TrxAVR-Picastar by G3VPX.

These pages are by VK3PE for construction of the TrxAVRB I/F PCB's.

Errors on the PCB:-

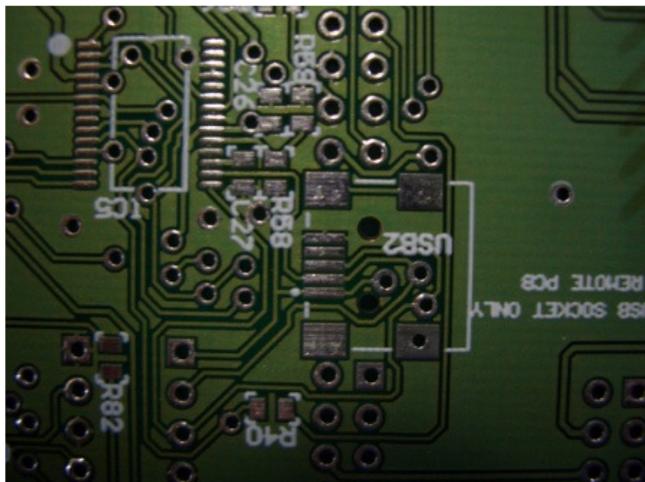
There is an error on the central "USB2" connector. This probably won't be a problem to most builders. There is no ground connected to the top pin. (the very centre of picture, just to right of "R58") This USB connector though is ONLY used if the central section of the PCB is removed, as per the information above. There is a ground hole just to the left side of C27 so a short near horizontal wire could be fitted. Normally, the other USB connector further to the right will be used, or a remote USB socket.

The 8 button keypad (right hand small PCB on panel)

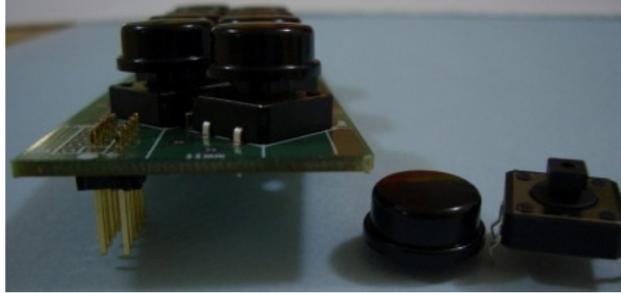
The holes for the 10 way IDC connector have been drilled 2mils (2 thousands of an inch) undersize. This does not sound like much but the connector will NOT go in. The best way to solve this problem is to use a sharp knife and scrape two corners of each pin of the connector a little, until it can be comfortably inserted into the PCB. Do NOT drill the PCB holes out as they are plated through holes and you will lose connectivity.
